NOTE - CONSTRUCTION ISSUE C03

SITE/PROJECT: **A59 KEX GILL DIVERSION**

TITLE: **Landscape Ecology Mitigation Monitoring and Management Plan (Sheet 5 of 10)**

DRAWING NO: **NYKGDD-WSP-ELS-SG-DR-LE-00031** REV: **C03**

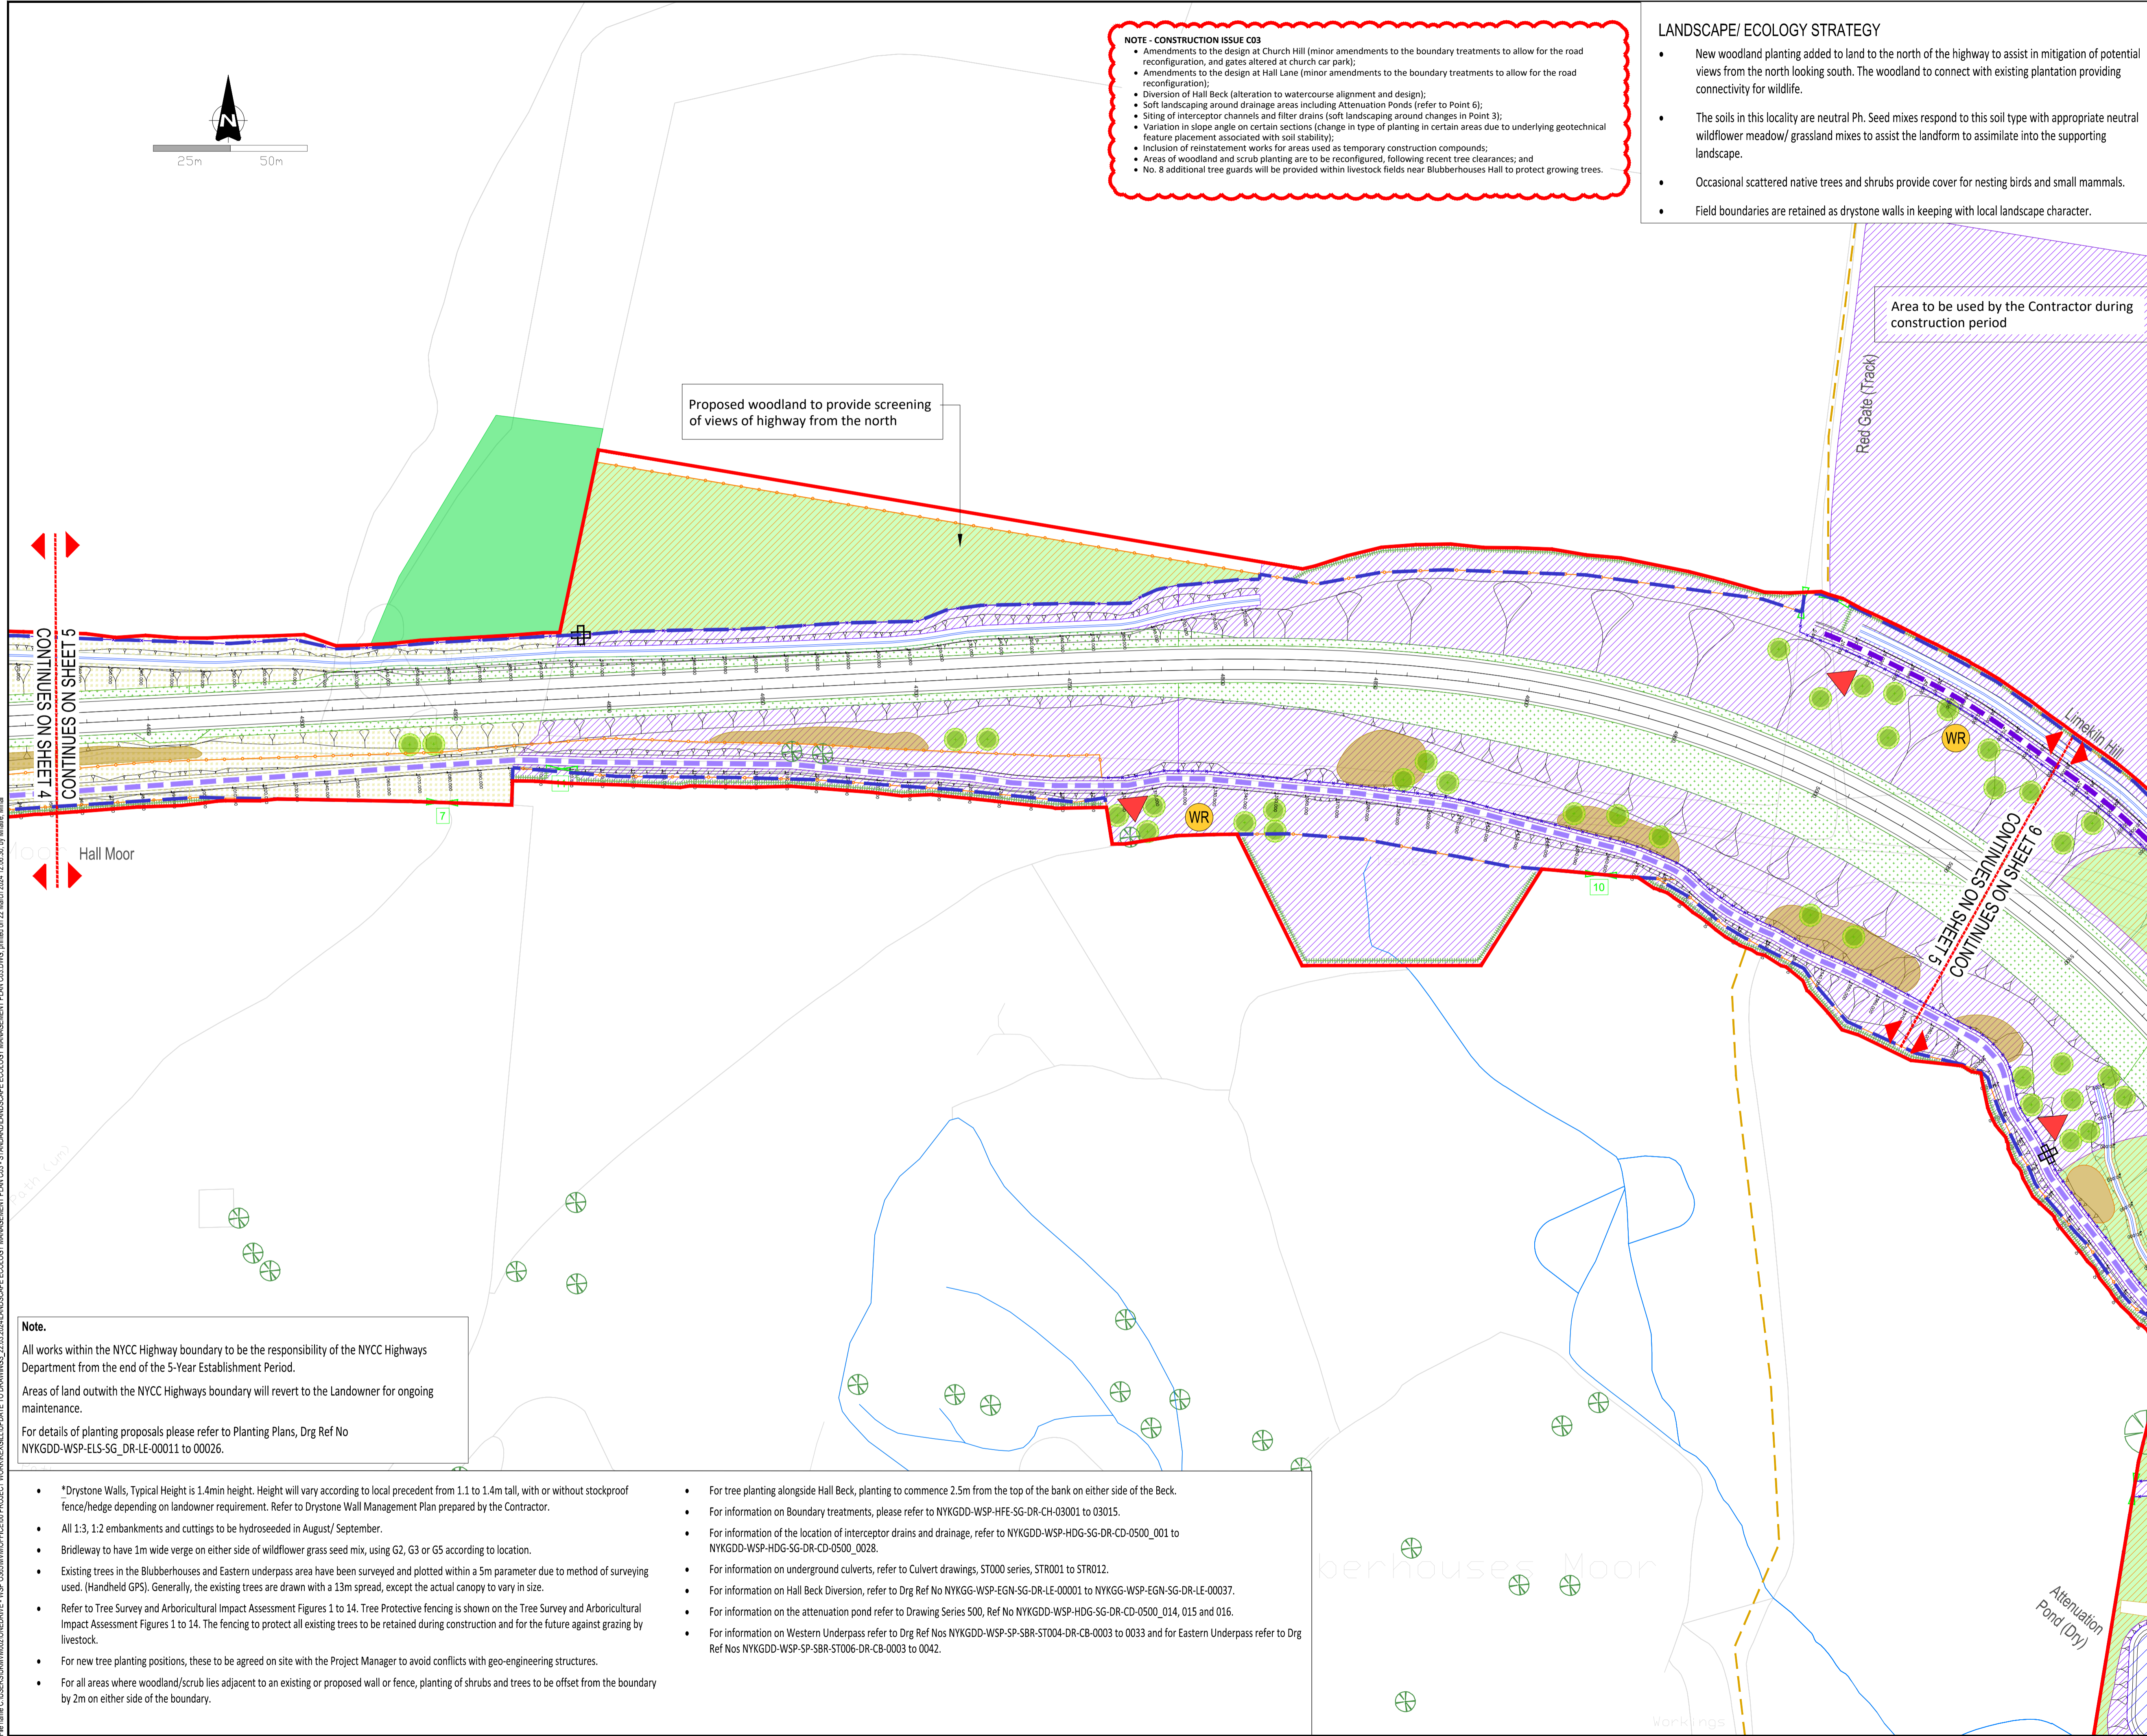
- Amendments to the design at Church Hill (minor amendments to the boundary treatments to allow for the road reconfiguration, and gates altered at church car park);

- Amendments to the design at Hall Lane (minor amendments to the boundary treatments to allow for the road reconfiguration);
- Diversion of Hall Beck (alteration to watercourse alignment and design);

- Soft landscaping around drainage areas including Attenuation Ponds (refer to Point 6);
- Siting of interceptor channels and filter drains (soft landscaping around changes in Point 3);

- Variation in slope angle on certain sections (change in type of planting in certain areas due to underlying geotechnical feature placement associated with soil stability);

- Inclusion of reinstatement works for areas used as temporary construction compounds;
- Areas of woodland and scrub planting are to be reconfigured, following recent tree clearances; and

- No. 8 additional tree guards will be provided within livestock fields near Blubberhouses Hall to protect growing trees.
